Coefficient Update SM

Andre Szczepanek

Texas Instruments

Proposed State Machine (one per tap)

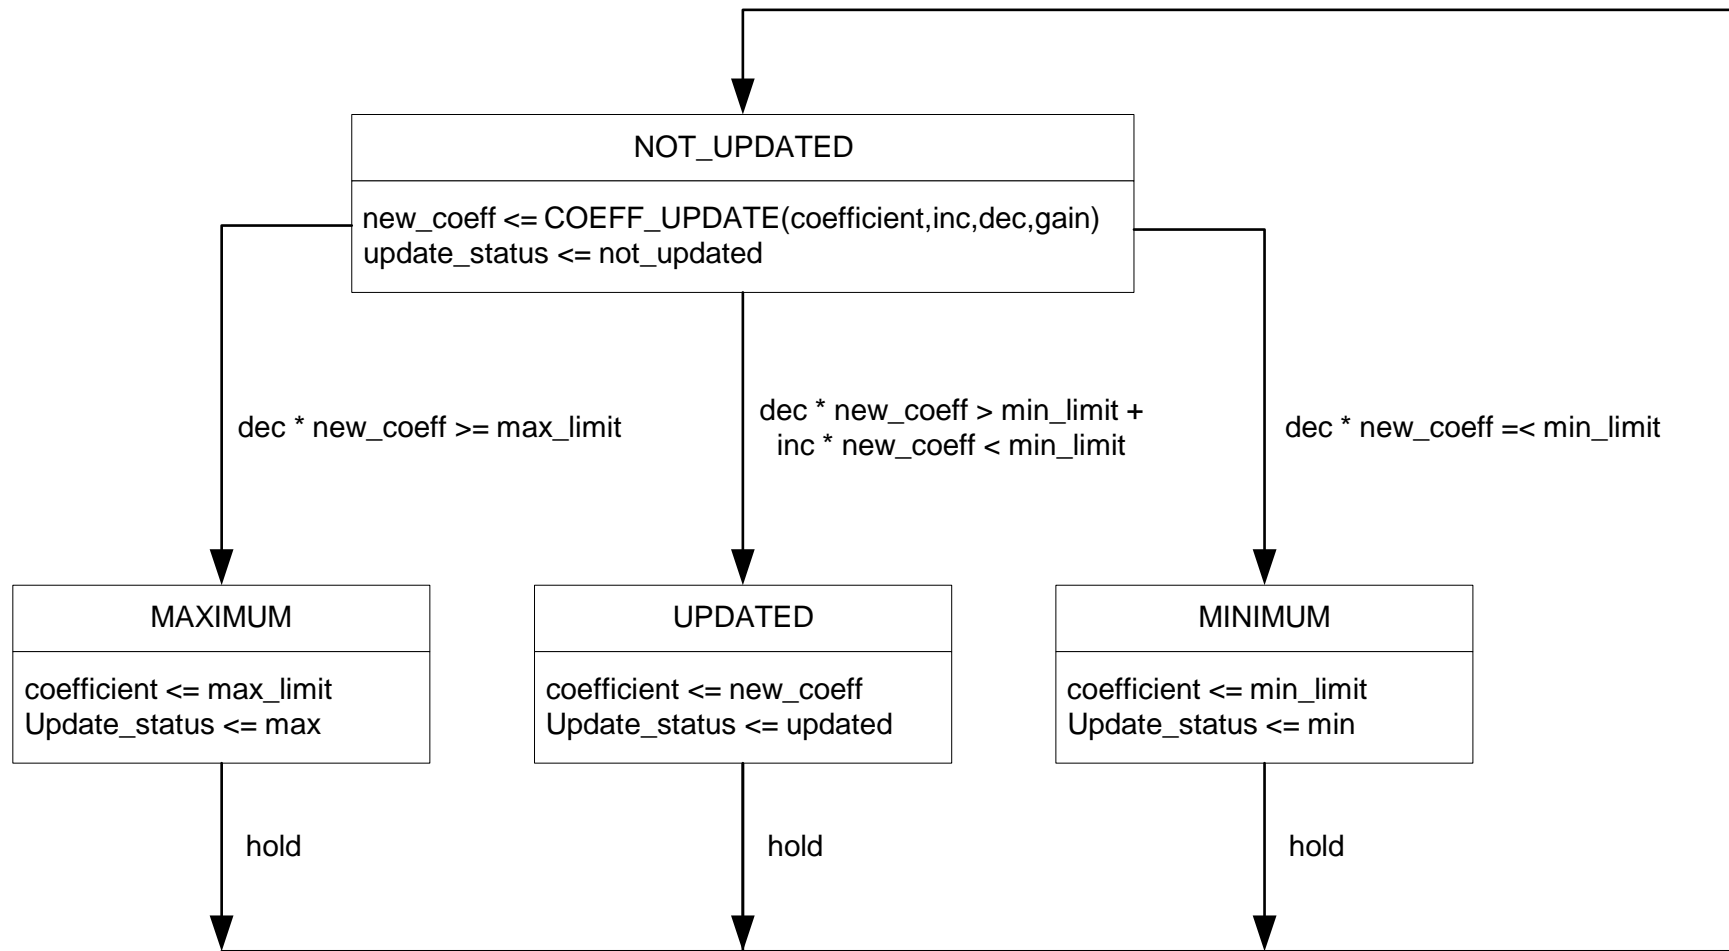
- Coefficient updating is a state dependant process
 - State dependant processes are best defined using State Machines
 - Clearer, less ambiguous than textual descriptions
- The terms Over-run & Under-run imply arithmetic rollover and corruption
 - What we have is non-destructive saturation of tap values
 - Change “over-run” to Maximum limit or max
 - Change “under-run” to Minimum limit or min
 - Indicate max, or min whenever limits are reached
 - Versus when they are exceeded
